# PCN-20180511 TE0841-01 to TE0841-02 Hardware Revision Upgrade

| <b>PCN Number</b> | PCN-20180511  |
| <b>Subject</b>    | Hardware revision 01 to 02                                    |

### #1 Change SPI Flash from N25Q256A11E1240E to N25Q512A11G1240E

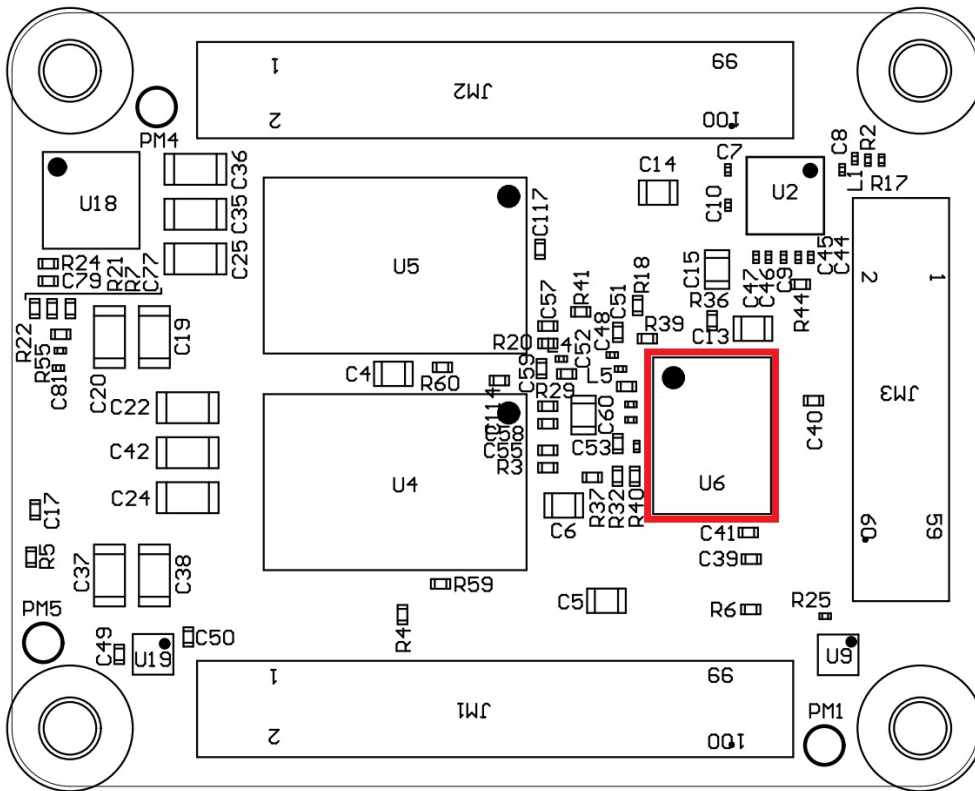
**Reason:** N25Q256A11E1240E became obsolete, the replacement part is not available for purchase. This is only an interim solution, because N25Q512A11G1240E is also obsolete already. It will be changed after the replacement parts will be available.

**Impact:** size changed from 256 MBit to 512 MBit per chip. JEDEC ID changed from BB19h to BB20h, both with manufacturer ID 20h.
